Subject: NRC Requirements for Auxiliary Feedwater Systems  
R. E. Ginna Nuclear Power Plant  
Docket No. 50-244

RESPONSE TO ENCLOSURE 1 TO OCTOBER 22, 1979 LETTER

NRC REQUIREMENTS FOR AUXILIARY FEEDWATER  
SYSTEMS AT ROBERT E. GINNA NUCLEAR  
POWER PLANT, UNIT 1

RGE  
UNIT #1  
STEAM DRIVEN  
AUXILIARY FEED  
WATER PUMP

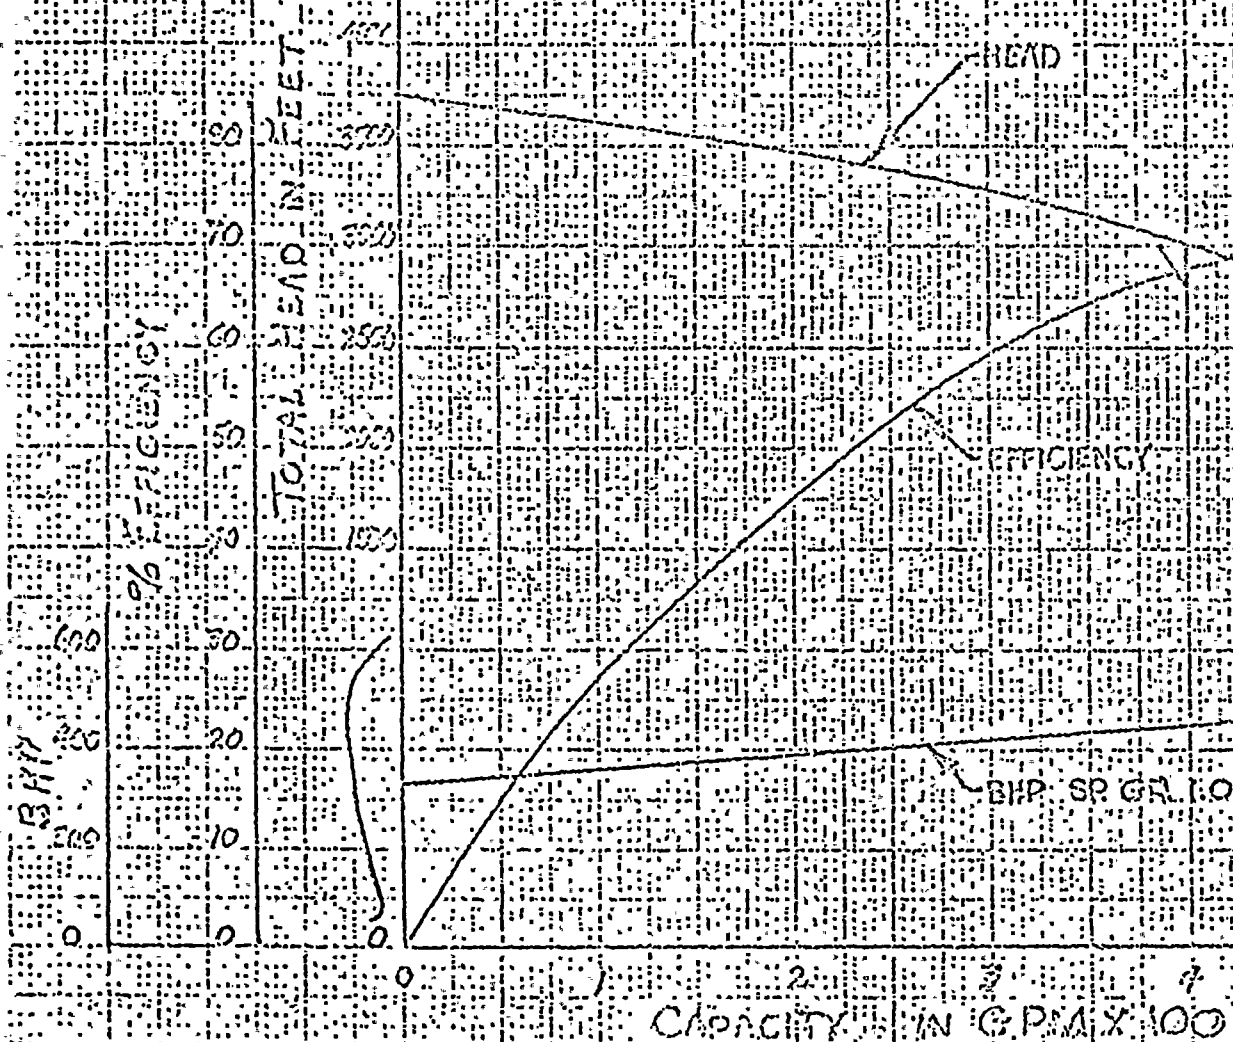
- c) What is the relationship between pump brake horsepower vs. flow.

Response: See final figure of attachment 1.
